TECHNICAL BULLETIN

12000 Silicone Hose Advisory

May 25, 2021
ISSUE: 052521

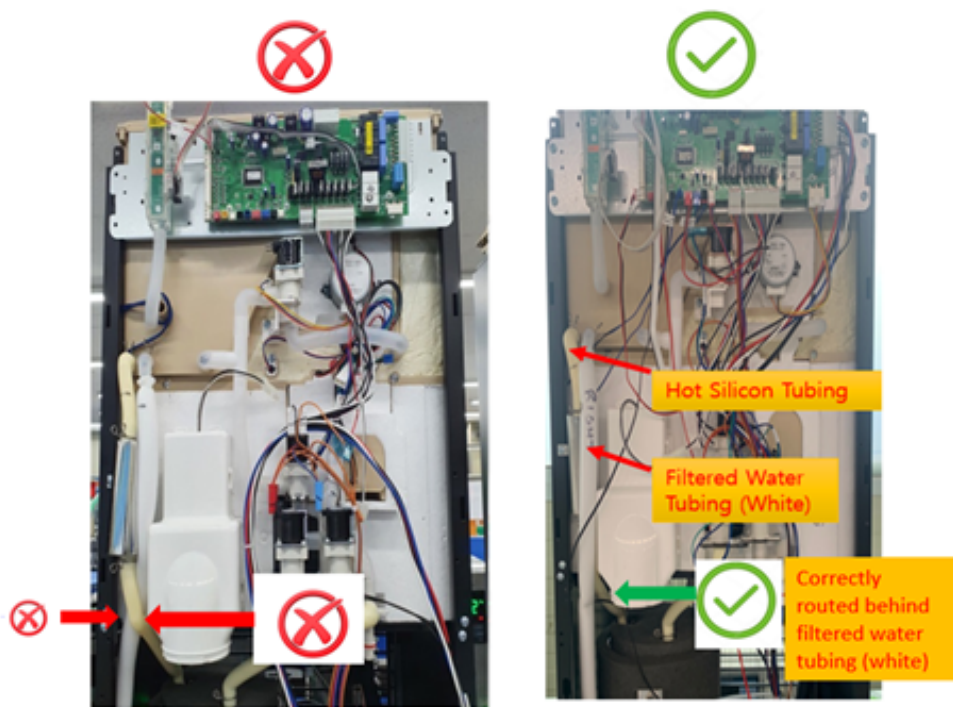
On certain units, the silicone tube connecting the water reservoir to the hot tank has been routed differently from its typical configuration. In some instances, this revised routing has increased the tension on the tubing, causing it to separate from the hot tank, resulting in a leak.

As illustrated in the picture at left below, the image with the **RED 'X'** shows the silicone tubing routed in front of the white tubing, which can create additional tension on the silicone tubing.

The image at right below with the **GREEN** check marks illustrates the silicone tubing properly routed behind the white tubing.

If applicable, please change the routing of the silicone tube to run behind the water line.

Verify that the silicone is properly seated to the hot tank.

Hose clamp example. Ensure it is pressed all the way down.

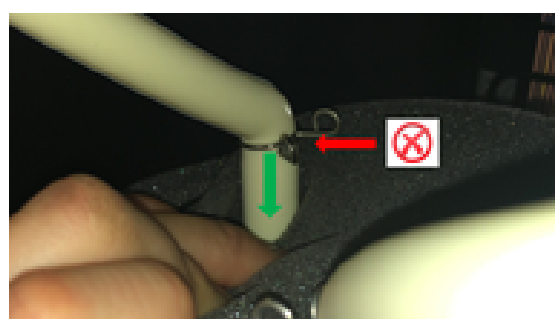
At time of system preparation, visually inspect that the tubing is routed correctly (please see the illustration above for reference) and that the clamp is properly secured (please see below image).

Verify that the clamp is properly secured to the metal inlet tube coming from the hot tank.
